APPLICATION NO.	FILING DATE	FIRST NAMED INVENTOR	ATTORNEY DOCKET NO.	CONFIRMATION NO.
10/628,646	07/28/2003	Quan-Chiu Harry Lam	HSJ920030043US1 (HITG.024)	4890
51298	7590	09/20/2005	EXAMINER	
CRAWFORD MAUNU PLLC 1270 NORTHLAND DRIVE SUITE 390 ST. PAUL, MN 55120			HEINZ, ALLEN J	
			ART UNIT	PAPER NUMBER
			2653

Office Action Summary

Addendum A

FIG. 4

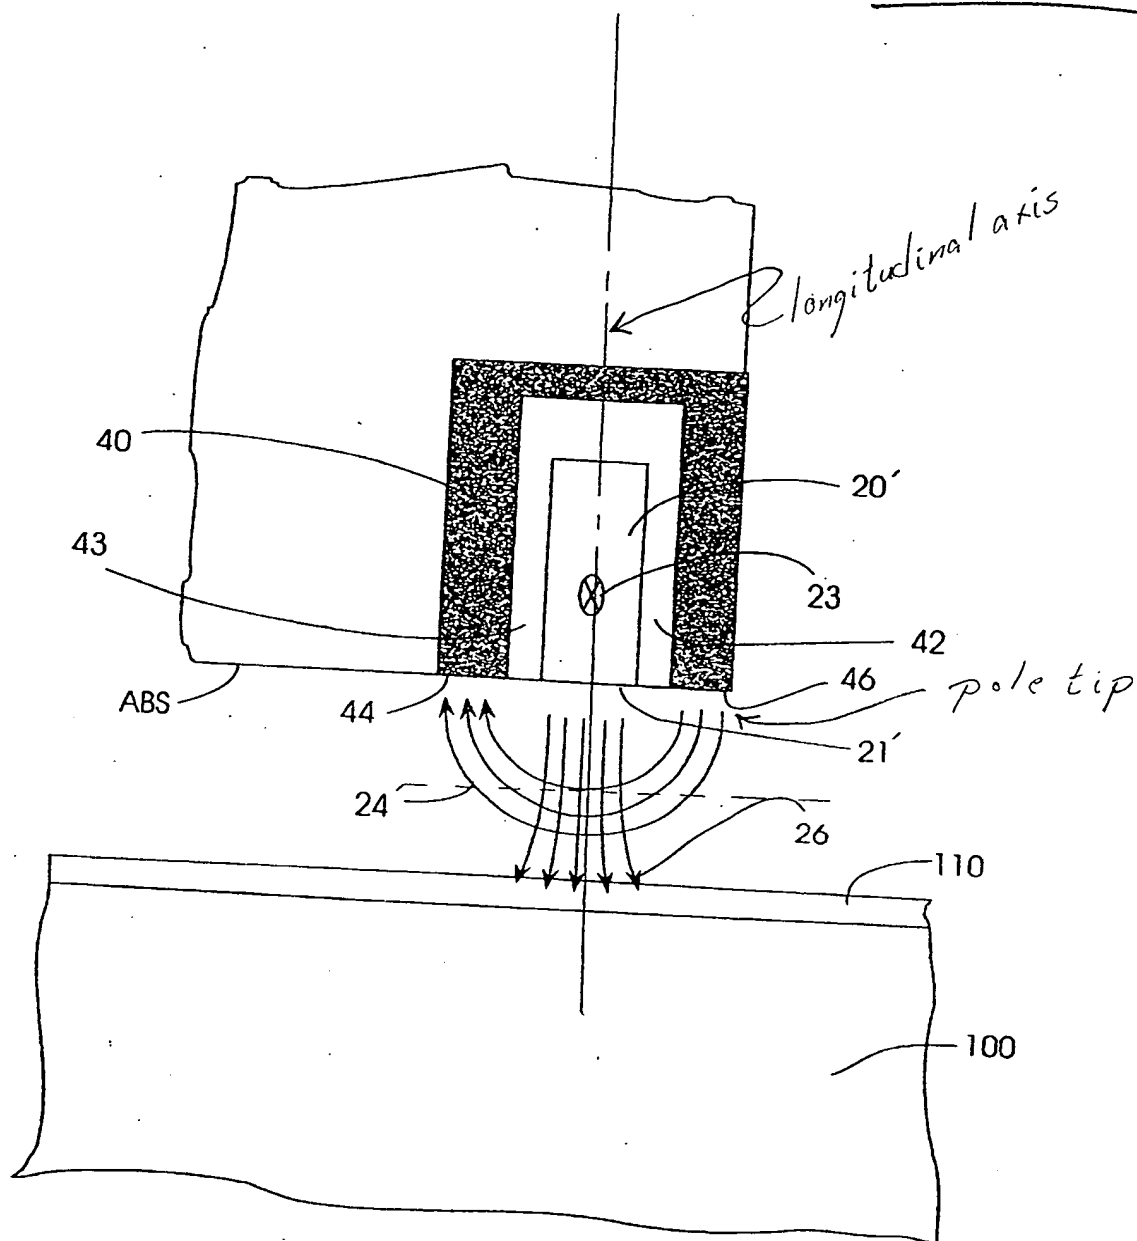
3. Claims 1-3 are rejected under 35 U.S.C. §102(e) as being anticipated by Hsu.

See Fig. 4. Note, to the extent claimed and understood, the structure as shown in Addendum A reads on and performs to the same degree as claimed. The magnetic field (24') generated by bias source 20' at the air bearing surface of the pole tip 46 is substantially transverse to the longitudinal axis of the head.
